ATTACHMENT B

Public Comments Received on Pasadena Water and Power's 2020 Urban Water Management Plan and Water Shortage Contingency Plan

Ken Kules' comments on Pasadena Water and Power's "2020 Urban Water Management Plan - Public Draft"

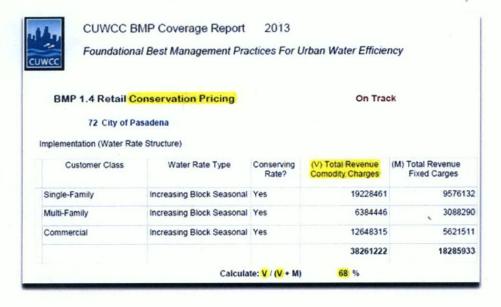
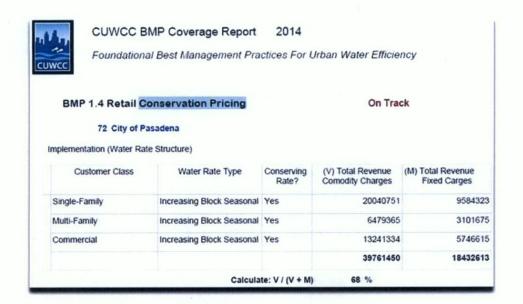
The CUWCC annual analysis of Conservation Pricing is no longer conducted, but an examination of CUWCC's historical calculation regarding Pasadena's water rates is instructive:

As shown above, the CUWCC analysis of Pasadena's water rates for 2013 and 2014 showed that Pasadena's water rate structure was 68% - less than 70% - in both years and was not "consistent with the definition of conservation pricing."

3.	Table 9.2 describes only the volumetric Commodity Rate and not the Distribution and Customer Charge, as the California Urban Water Conservation Council (CUWCC) defines conservation pricing. The CUWCC analysis of Pasadena's water rates shows a score of less than 70% and was not "consistent with the definition of conservation pricing".	3.	Mr. Kules correctly states the CUWCC annual analysis of conservation pricing is no longer conducted, therefore these definitions do not need to be considered in the UWMP. PWP emphasizes equitable rates based on cost-of-service and has a goal to achieve a 70% score for conservation pricing. Achieving scores of 66-68% is not quite 70%, but is categorized as "on track". While a laudable goal, the methodology is out of date. PWP continues to strategize on updating water rates that also progress conservation pricing efforts.

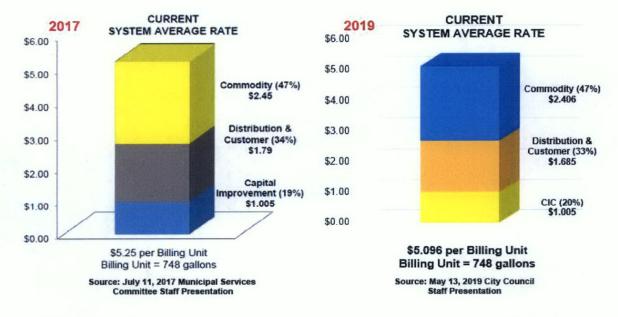
In 2017 and 2019, the Conservation Pricing calculations were even lower than 2013 and 2014 at 66% and 67%, respectively:

The above information must be considered in evaluation of Pasadena's Conservation Pricing.
